# Applicant Materials for Consideration – Planned Unit Development Modification

145, 151, 176, 195, 350 & 400 Dunlap Drive

• Major Modification of a previously approved Planned Unit Development.

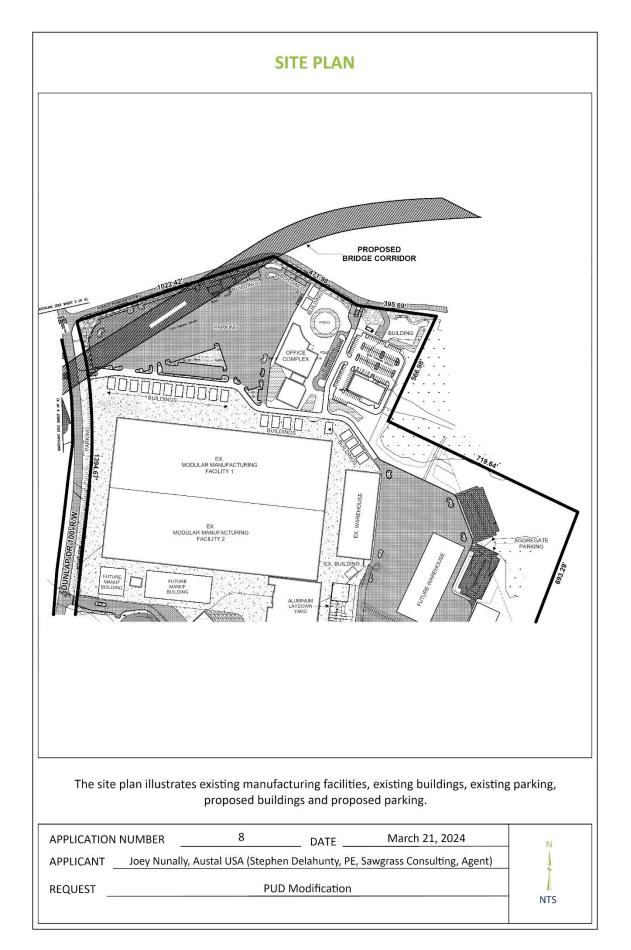
The site plan provides parking numbers for current parking requirements, spaces provided, those displaced and those replaced, but does not provide any calculations for future requirements for the proposed new buildings throughout the site based on the square footage of office space or the number of manufacturing/warehousing employees. The UDC stipulates that any parking spaces in excess of the minimum requirement must be Alternative Surface. However, due to site being zoned I-2, the entire parking areas could be an approved Alternative Surface – gravel (64-3-12.A.5.(c)(3) and 64-3-12.A.5.(d)(3)). In terms of parking there are other considerations involved, such as the provision of pedestrian safety aisles (64-3-12.A.5.(i) and (j)) and the provision of bicycle parking as per 64-3-12.A.9.(b).

The site plan does not indicate dumpsters, nor are there any notations stating that dumpsters will not be utilized and refuse collection will be either via curbside service or private can collection.

- 3. Placement of a note on the recorded site plan stating that complaint parking calculations for the over-all site will be provided as each proposed building is submitted for approval (based on the square footage of office space and the number of manufacturing/warehousing employees);

- 4. Revision of the site plan to provide pedestrian safety aisles (64-3-12.A.5.(i) and (j)) within all parking areas;
- 5. Revision of the site plan to provide bicycle parking as per 64-3-12.A.9.(b);

- 6. Revision of the site plan to indicate compliant dumpsters, or the placement of a note on the site plan stating that dumpsters will not be utilized and refuse collection will be either via curbside service or private can collection;
